FALCON MEADOW RV CAMPGROUND

OUTFALL LIFT STATION 1041 APPLICATION

**1041 PERMIT APPLICATION SUBMITTAL
FOR
FALCON MEADOW RV CAMPGROUND
OUTFALL LIFT STATION**

APRIL 2019

EXHIBIT K – LAND USE MAP

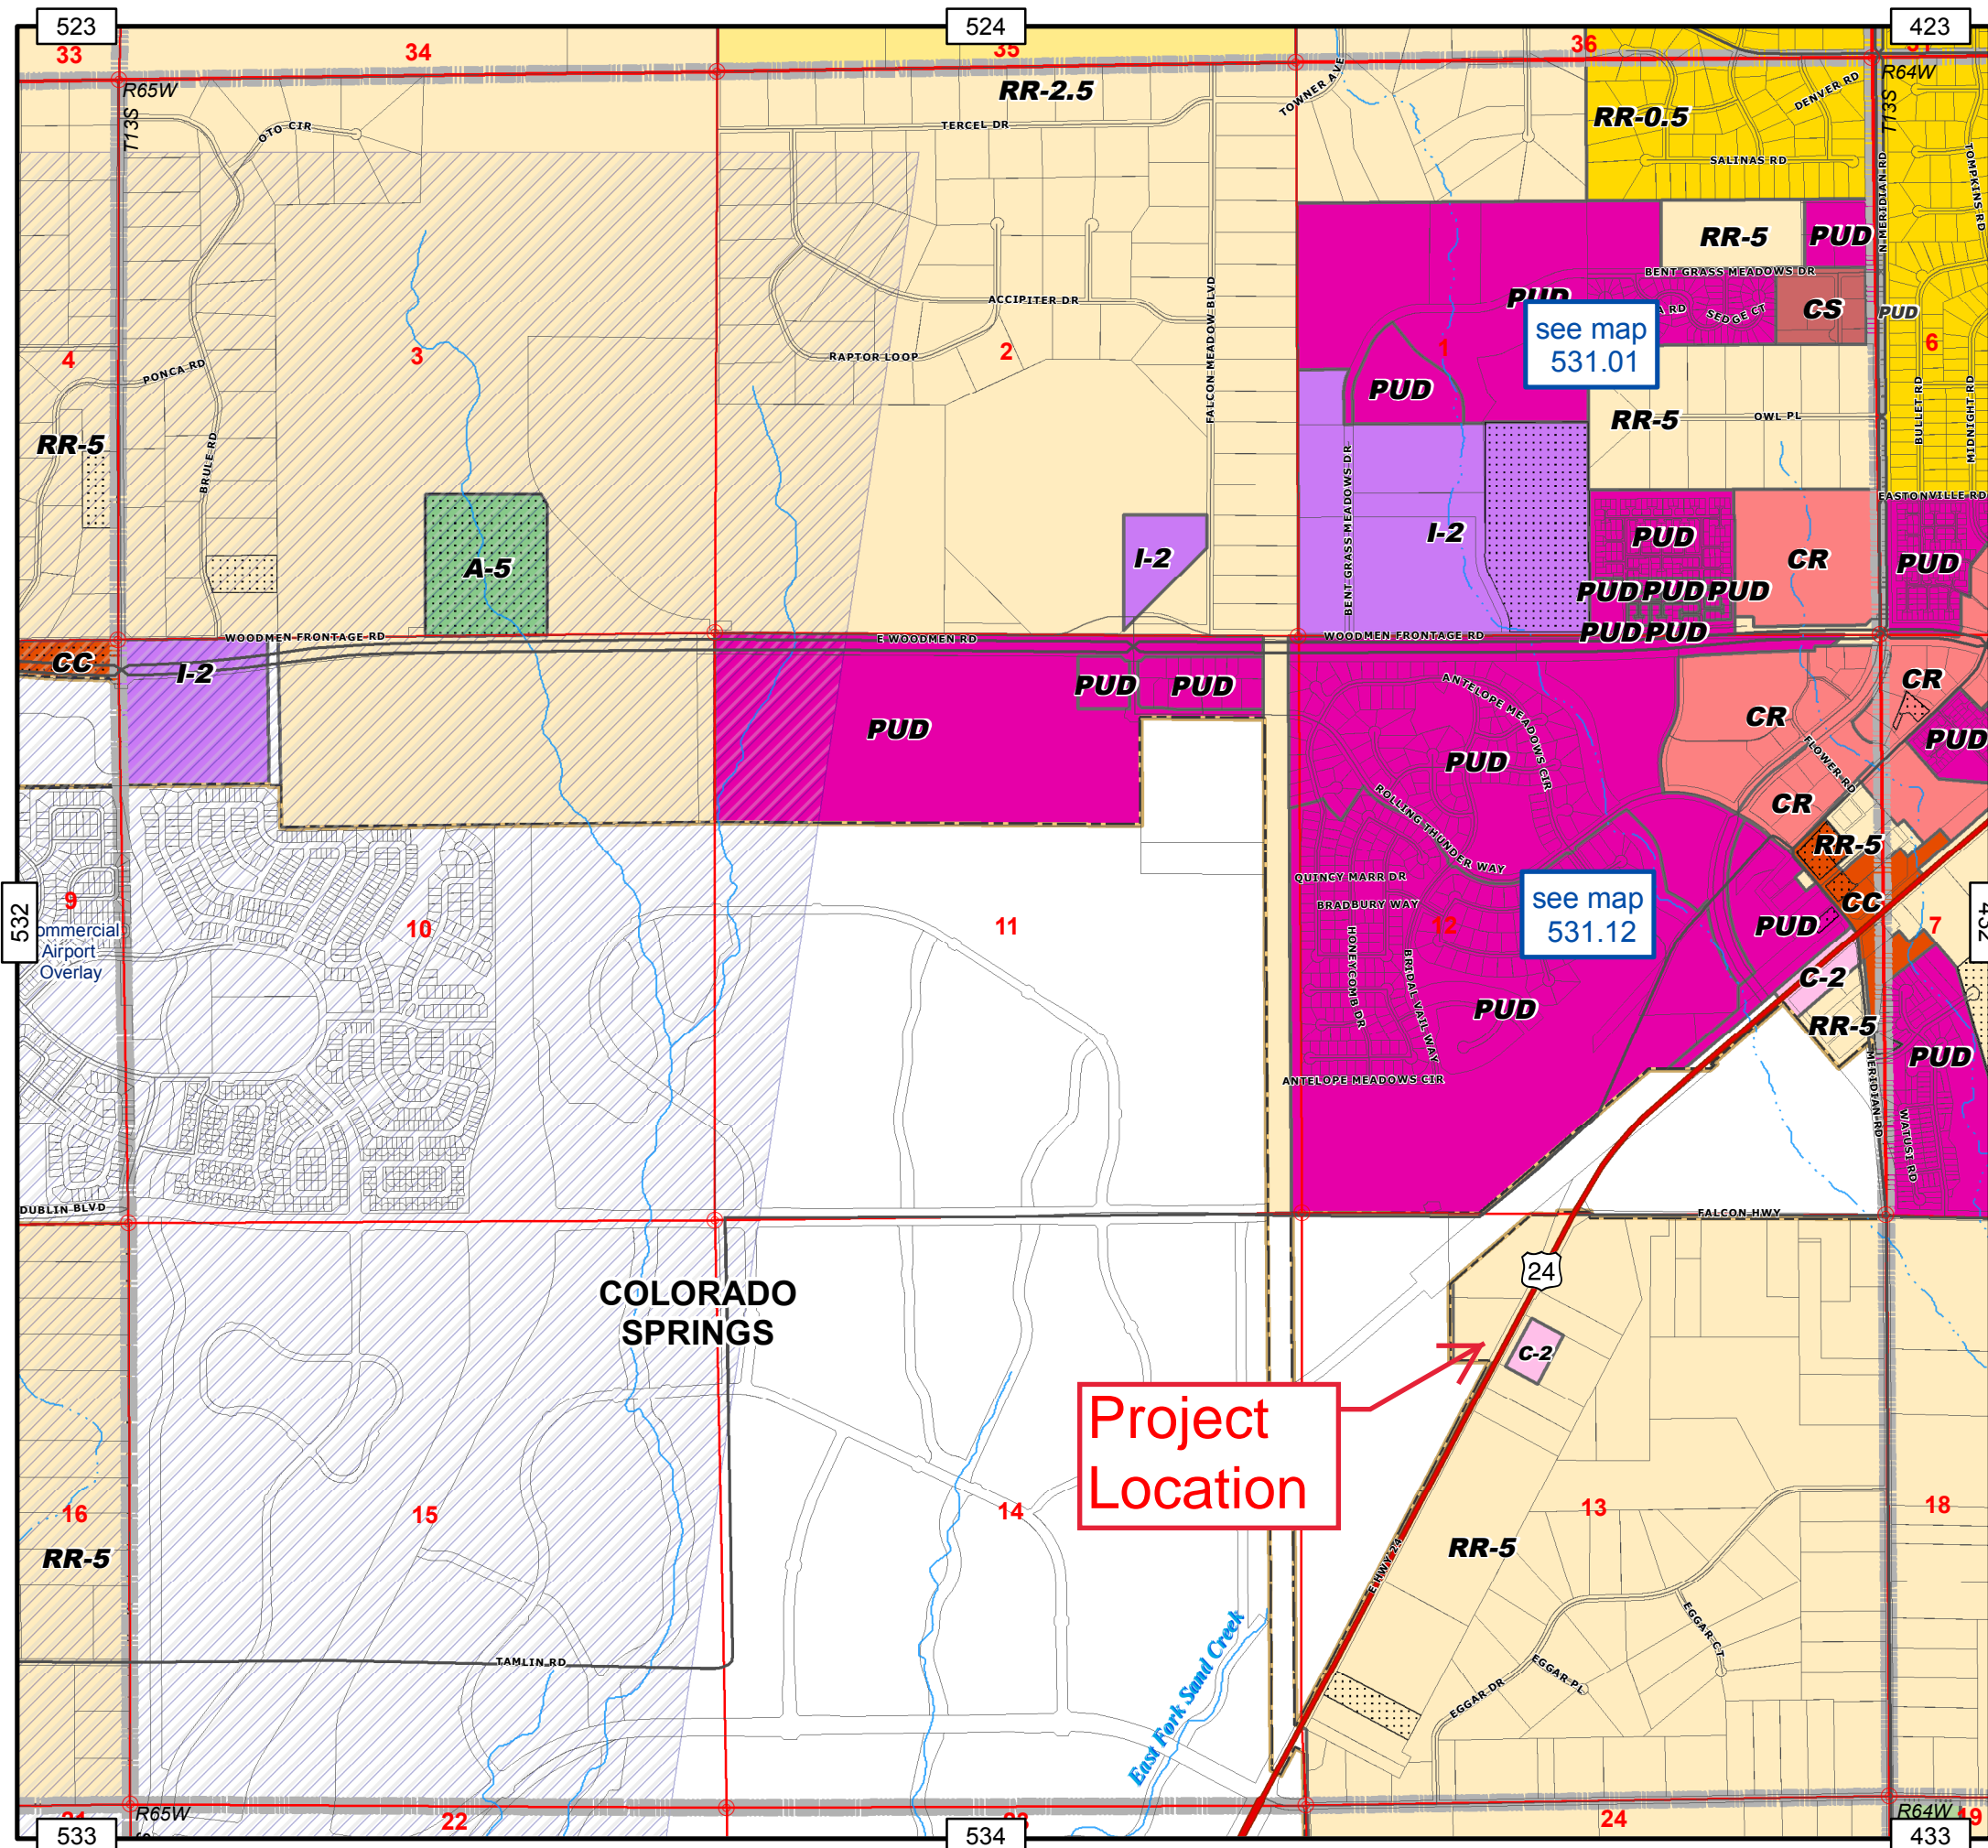
please update the map and add all required information
